MARINE SCOTLAND SCIENCE RESPONSE

DRA-533
CP-1520-3 (Version 1)
AGR Chemical Permit 204/10a-Cambo

CAMBO PHASE 1 FIELD DEVELOPMENT ENVIRONMENTAL STATEMENT

A Technical Review of the permit renewal
Environmental Impact Assessment (EIA)
for the
Cambo Oil Field
United Kingdom Continental Shelf
Blocks 204/4a, 204/5a, 204/9a and 204/10a

Map 2 The distribution of protected features within the Faroe Shetland Sponge Belt MPA

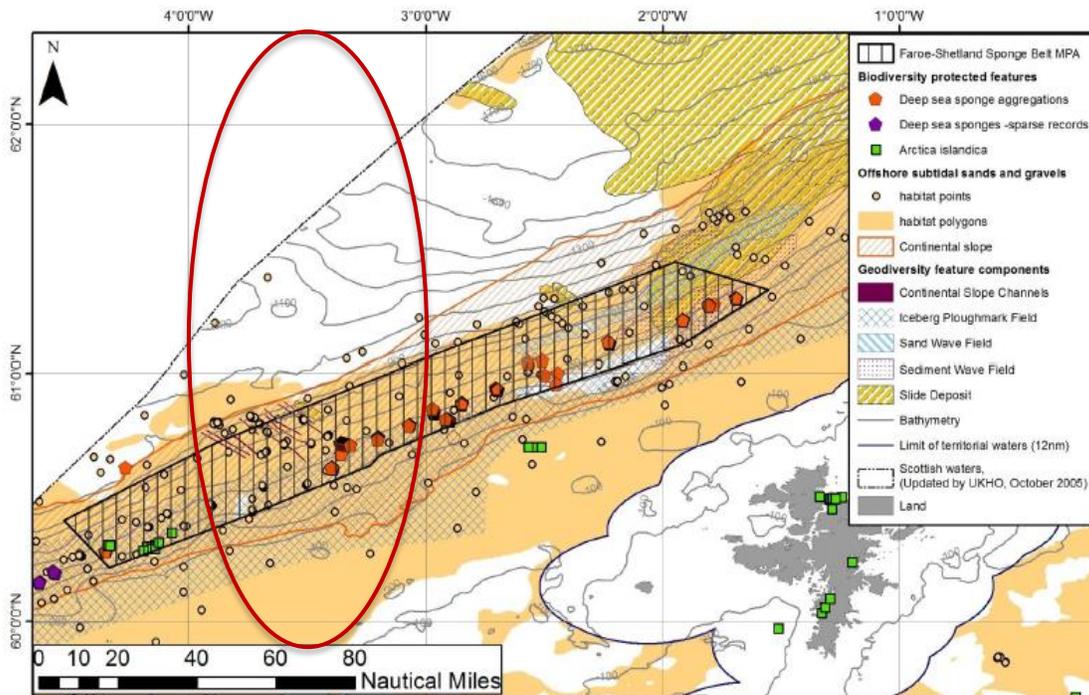
The route for this pipeline cuts straight through the Faroe-Shetland Sponge Belt Nature Conservation Marine Protected Area for 34.8 km, as shown in the two images below. The first image is the EIA pipeline path; the second image is the MPA, showing the location of various protected species. The red oval shows the overlap between the two areas.

However, this characterization fails to include nearby areas and species aggregations, which will be affected by sediment plumes as the pipeline is being laid down, as well as potentially being harmed if there is an oil spill or leak of any kind. Simply surveying the exact track where a pipeline will be laid fails to account for the realities of working in moving currents deep below the water surface. The pipeline is bound to shift with storms, and in any event, many of the species identified in the baseline survey are mobile, which means they might not have been present during the survey but may be attracted to the area once the pipeline is in place. The EIA reports myriad benthic species in the area, including, “...sea fans, sponges, sea anemones, stalked hydroid and faunal turf, sea spiders, starfish, burrowing anemones, burrowing hexacorals, sponges, small soft corals and bryozoans.”¹⁰

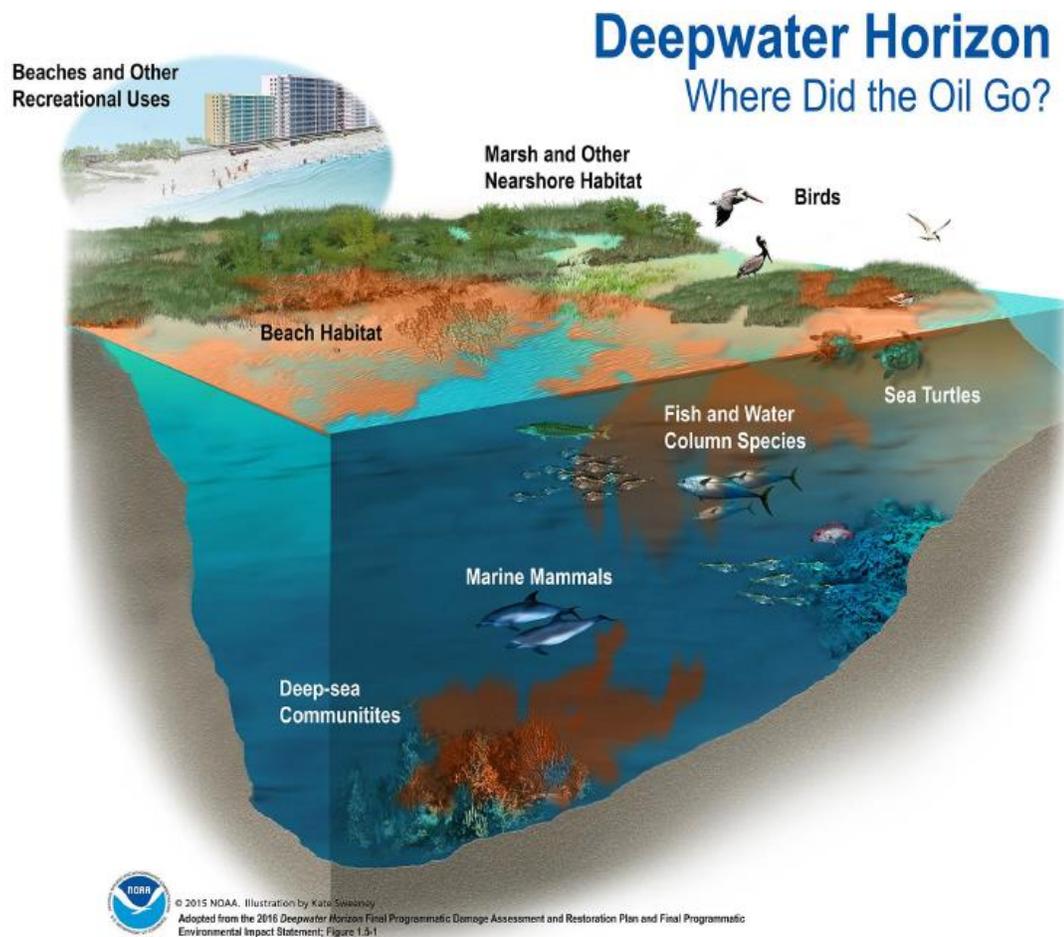
“Any subsea release of crude oil would be pushed directly up in a plume to the sea surface, rather than towards the surrounding benthic communities. It would then be carried away from the spill location by the local current systems, with the majority of the oil moving to the northeast (Figure 13.7). Due to the time it would take to reach these areas and the large surface area available for microbial attack, it is expected that most of the toxic constituents would have been lost from the plume. It therefore seems unlikely that the released oil would significantly affect either suspension feeding or the more prevalent deposit feeding species comprising deep-water benthic communities.”²⁶

The U. S. National Oceanic and Atmospheric Administration produced a simple infographic to explain what happened to the released oil during the Deepwater Horizon blowout. The infographic,²⁷ pasted in below, indicates that a substantial amount of the oil spilled from the well underwater (shown in brown) stayed underwater, where it caused
